WST 49X Hood Headlight Wiring Too Short

TSB 54-099

To Be Published: Q2 2025

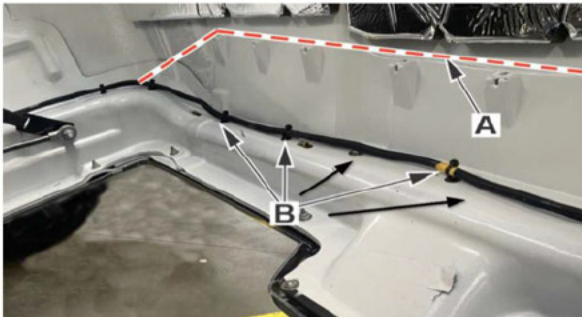
- TSB solution for an uncontrolled routing of the headlight wiring harness
- Headlight harness wiring was too short for 49X trucks equipped with the optional power hood built before 4/17/24
- In the picture below A was the intended routing path, and B is the containment solution

- 4/17/24 Cleveland started drilling lower mounting holes and started using pushpin fasteners to retain the harness

- P66126 released longer hood harness for power hood
